CITY PLANNING COMMISSION

- APPLICATION:
1. Environmental Determination
 2. Rezone 37± vacant acres from Townhouse (R-1A) to Single Family (R-1) (Zoning Ord., Sec. B)
 3. Tentative Map (P83-386) (Subdivision Ord., Chapter 40)
 4. Amend the Rancho Coronado PUD Schematic Plan housing mix from single family, zero lot line and halfplex units to single family and corner lot halfplexes
 5. Special Permit for halfplex development (Zoning Ord. Sec. 7) WITHDRAWN
 6. Variance to create a lot in excess of 160 feet in depth (Zoning Ord., Sec. 2-E-19)
 7. Subdivision Modification to create a lot in excess of 160 feet in depth (Subdivision Ord., Chapter 40.322)

PROPOSAL: The applicant is requesting the necessary entitlements to amend the existing Rancho Coronado PUD and divide 42.5± acres into 206 single family residential lots.

APPLC. NO. P83-386

TENTATIVE MAP FOR		DATE
RANCHO CORONADO UNIT 2		REV. #1
CITY OF SACRAMENTO, CALIFORNIA		1

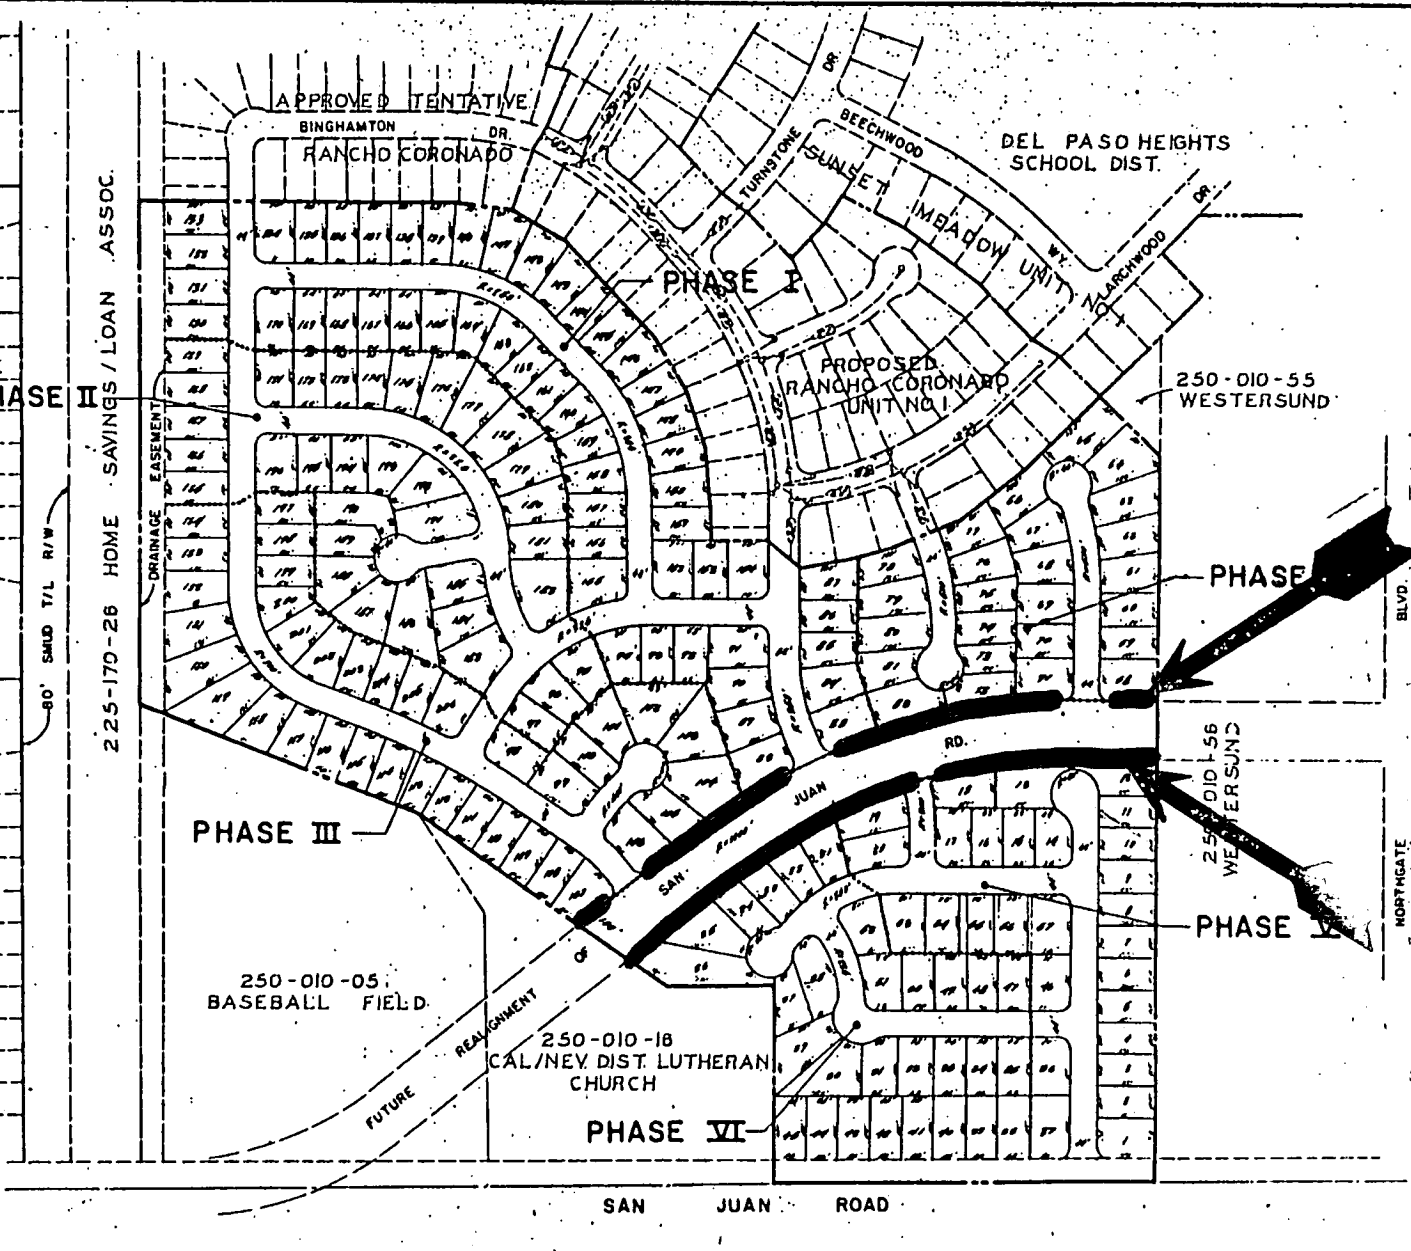
- a. Provide standard subdivision improvements pursuant to Section 40.811 of the City Code;
- b. Prepare a sewer and drainage study for the review and approval of the City Engineer;

- c. Pay off existing assessments or file the necessary segregation requests and fees to segregate existing assessments;
- d. Pursuant to City Code Section 40.1302 (Parkland Dedication), the applicant shall submit to the City an appraisal of the property to be subdivided and pay the required parkland dedication in-lieu fees. The appraisal shall be dated not more than 90 days prior to the filing of the final map;

- e. Pursuant to City Code Section 40.319-1, the applicant shall indicate easements on the final map to allow for the placement of centralized mail delivery units. The specific locations for such easements shall be subject to review and approval of the City Engineer after consultation with the U.S. Postal Service;

- f. The applicant/developer shall designate and place on the final map those structures and/or lots which will meet the required 80 percent south orientation (including solar access) to the satisfaction of the Planning Director;

- g. Construct two 18-foot off-site lanes to connect realigned San Juan Road with either Northgate Boulevard or existing San Juan Road. City will condemn right-of-way at developer's expense;

- h. Final map cannot be filed until Rancho Coronado Unit 1 is filed or full improvements on both sides of Larchwood Drive are constructed from its present terminus to Binghamton Drive;

- i. Dedicate a 50-foot right-of-way for street fronting between lots 107 and 127; for lots 19 and 20 and lots 58-71.

EXHIBIT A

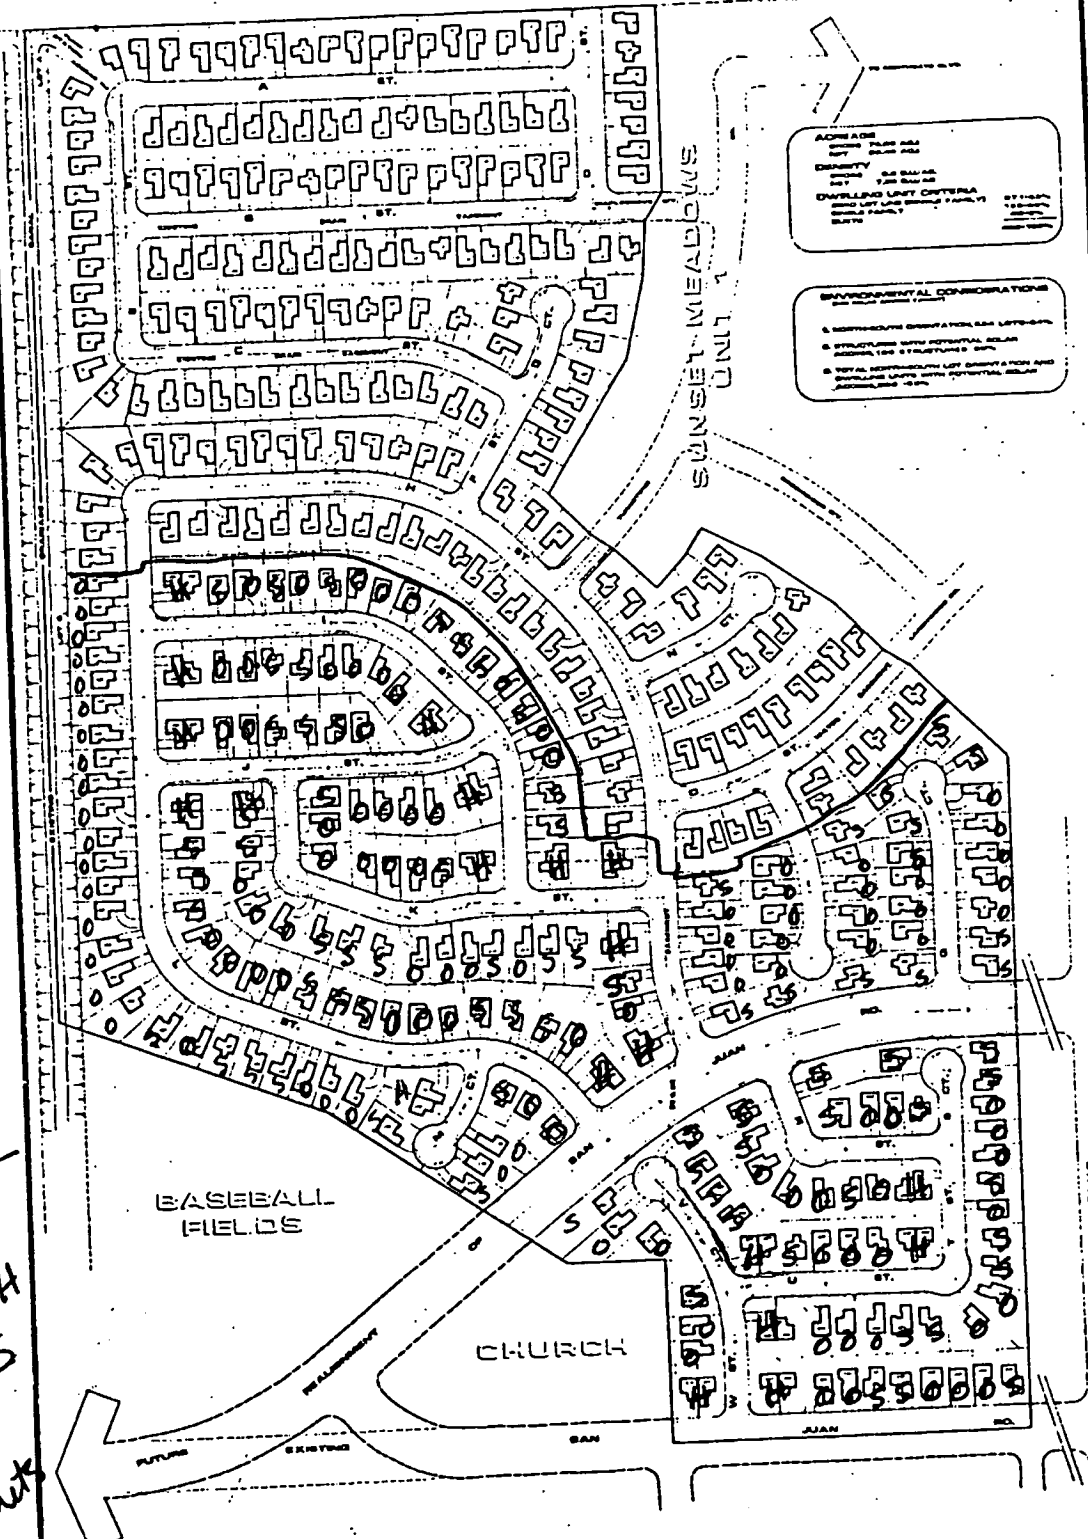
2. Staff, however, has concerns with the design of the subdivision. On February 8, 1984 the Planning and Community Development Committee will review various design alternatives for single family development. Specifically, staff has been directed to consider design alternatives which do not rely upon utilization of a masonry wall along major streets. Responsibility for installation and maintenance of the wall and landscaping installed between the wall and street has not been resolved. In addition, where breaks occur in the walls, problems have arisen due to direct access from the major street into the neighborhood. The applicant is proposing a design which could result in a wall along both sides of the San Juan frontage, creating an undesirable tunnel effect as well as the previously mentioned drawbacks (see Exhibit A).

STAFF RECOMMENDATION: Staff recommends continuance of the project to the February 23, 1984 regular meeting to allow the applicant time to redesign the subdivision according to design criteria recommended by the Planning and Community Development Committee on February 8, 1984.
